Process Sheet

Customer	CU-DAR001	Dart Helicopters Services	Drawing Name	WEARPAD
Job Number	31417			
Estimat. Number	12781			
P.O. Number	N/A	S.O. No.	N/A	
This Issue	3/21/2007			
Prsht Rev.	NC			
First Issue	N/A	Type	SMALL /MED FAB	
Previous Run	31132			
Written By				
Checked & Approved By				
Comment	Est Rev:A	New Issue 07-03-08 ec

A	06.12.18	NEW ISSUE
DESIGN <i>P4</i>	DRAWN BY <i>P4</i>	DART
CHECKED <i>[Signature]</i>	APPROVED <i>[Signature]</i>	DRAWING NO. D3564
DATE 06.12.18	TITLE WEARSHOE	REV. A SHEET 1 OF 2 SCALE 1:8

From: Peter Hum [mailto:phum@dart Aero.com]
Sent: Thursday, April 12, 2007 2:30 PM
To: 'David Shepherd'
Cc: 'Chris Provencal'; 'Jason Murdoch'; 'L Lacelle'
Subject: stainless steel wearplate with gasket tab widening

D3564-1F FLAT PATTERN

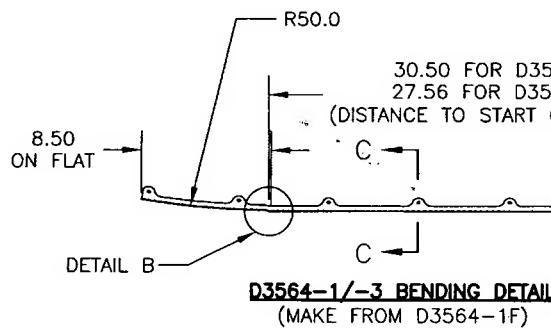
I can't understand why we are just finding out now that the flat pattern is 0.100" to 0.120" too narrow the day before we want to ship the parts. It seems to me this could have been tried with one small prototype piece on a couple sets of holes before we programmed and cut multiple parts on the waterjet. When I sign the drawings, I am assuming all of this stuff has been worked out. I would guess that the programmers are making the same assumption.

For future shipments the flat pattern will need to be updated.

REMOVE
MATERIAL

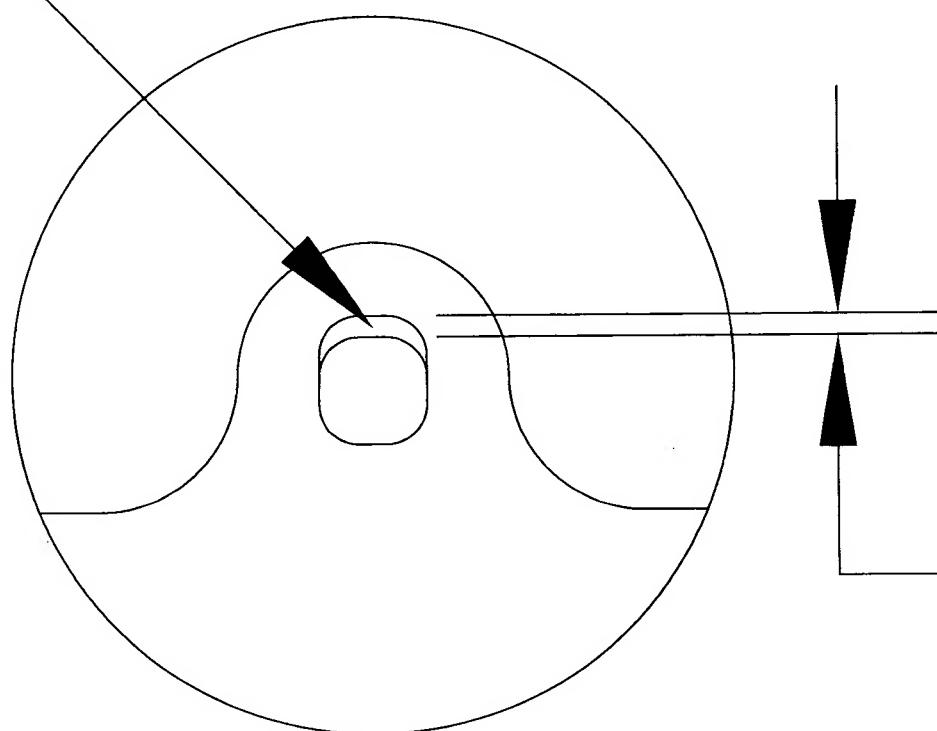
NCR:		WORK ORDER NON-CONFORMANCE (NCR)						
DATE	STEP	Description of NC Section A	Corrective Action Section B			Verification Section C	Approval Chief Eng	Approval QC Inspector
			Initial Chief Eng	Action Description Chief Eng	Sign & Date			
07.04.17	9	TABS WILL NOT FIT SKIRTURE	BB 07.04.17 P01 C257 042	OPEN TABS, REMOVE 0.060" MATERIAL SEE ATTACHED	07.04.19 BB 07/04/17	N 07/04/17		J 070417

We are trying to ship a 206L/407 float skidtube with stainless steel wearplates and the rubber gasket. Upon assembly we have found that the extra thickness the gasket gives, causes a difficult fit for the wearplate.

Jason opened the holes on the tab and the bolts not fit properly, to join the wearplates to the skidtube (see the attached pictures). We would have to open up all the wearplate tabs.

Is this an acceptable deviation for this shipment?

This is an acceptable deviation to me.

However, the parts have to be cleaned up considerably from what I saw in the pictures (deburred and paint touched up).
